Open Space Advisory Board

Agenda

Wednesday, October 5th, 2016
City Services Facility, 739 South 104th Street
7:00pm

To: Joe Stevens, Director of Parks and Recreation
From: Allan Gill, RLA, and Park's Project Manager
Date: October 6, 2016
Re: Clementine Subdivision Redevelopment, Preliminary PUD Information / Status Update

CONTEXTUAL
PUD PLANS

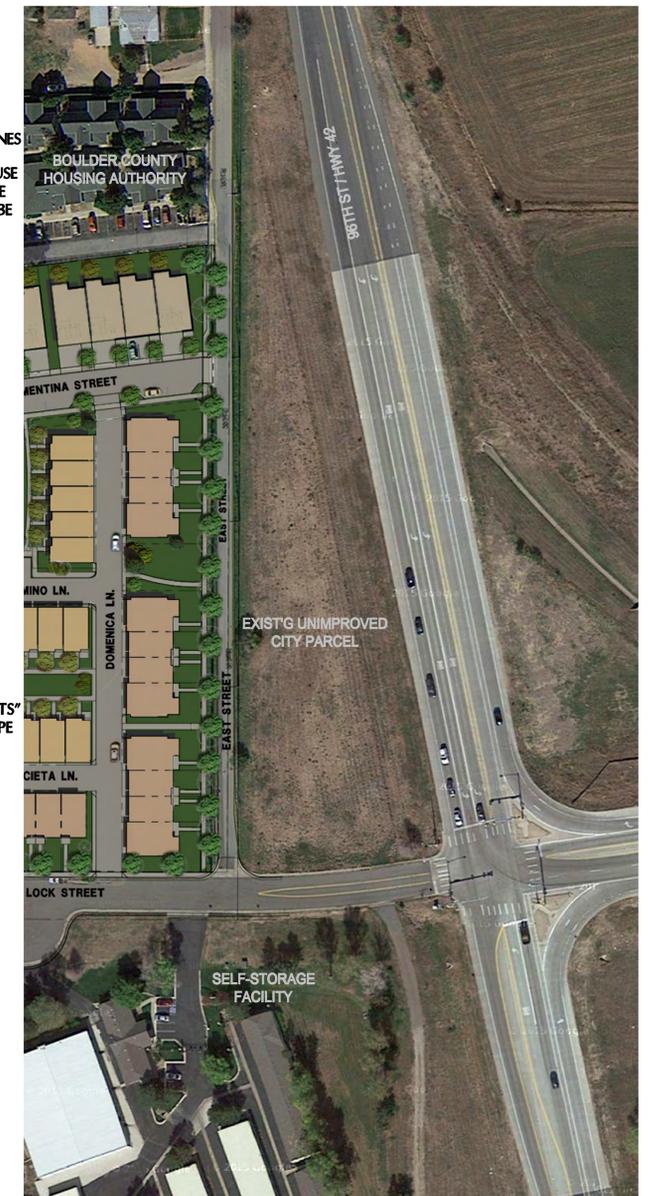
On August 10th staff met with the property owners and Hartrnft Associates to discuss the Clementine Subdivision (301-333 East Street). As a Planned Unit Development (PUD) the approval process is a negotiation between the City and the developer. The process starts very broad and becomes more focused at the end. This proposed development is not that different from other developments within the City; however, in this instance the developer is proposing to provide enhanced landscaping as a public benefit in addition to maintenance on an undeveloped City owned parcel of land adjacent to the east side of the development. In return the developer is asking to use a portion of the area for stormwater detention. As some stormwater detention basins tend to be very noticeable as a fairly deep hole the proposed detention area would be about a foot to a foot to eighteen inches in depth.

The triangular shaped parcel is approximately 1.4 acres +/- in size and is zoned as "Parks" in the Parks, Recreation, Open Space and Trails (PROST) master plan. Typically public land is not to be used for private use. In this instance the developer is proposing what they feel is a win / win situation.

Currently the City owned parcel of land is undeveloped and does not have a high Recreation or Parks value as the parcel is too small to be developed and maintained for active Park or Recreation purposes and the triangular shape also limits what the parcel can be used for.
